SUNSHINE COAST REGIONAL DISTRICT

ADDENDUM NO. 3

Invitation to Tender No. 2137017

Well Field Development and Water Treatment Plant

Replace Figure 1 on 8525-00-L-001 with the following

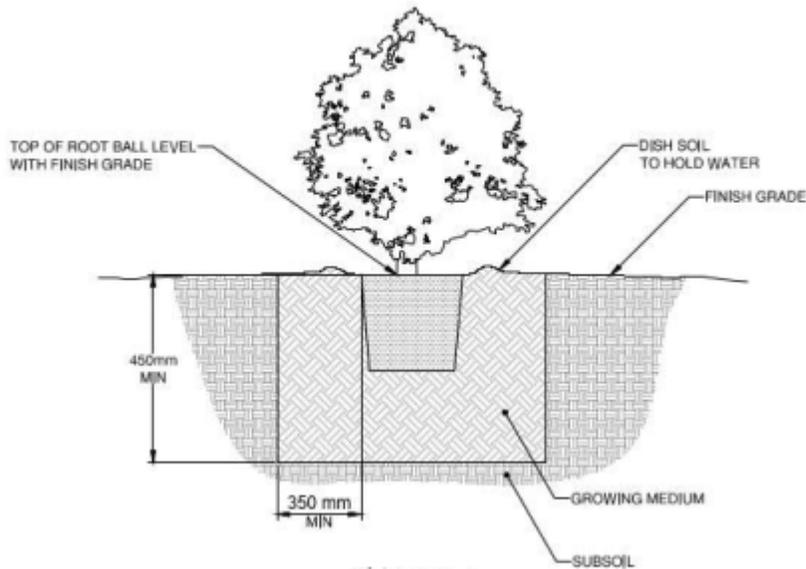
Question: It appears tree pits are (2.25m deep x 4m x 4m) 36m³ in volume each. Can you please confirm this value as it seems excessive? Please confirm tree pit and shrub pit required dimensions

Answer: Tree/Shrub pits to be a minimum of 450mm deep, and 350mm around as per details below.
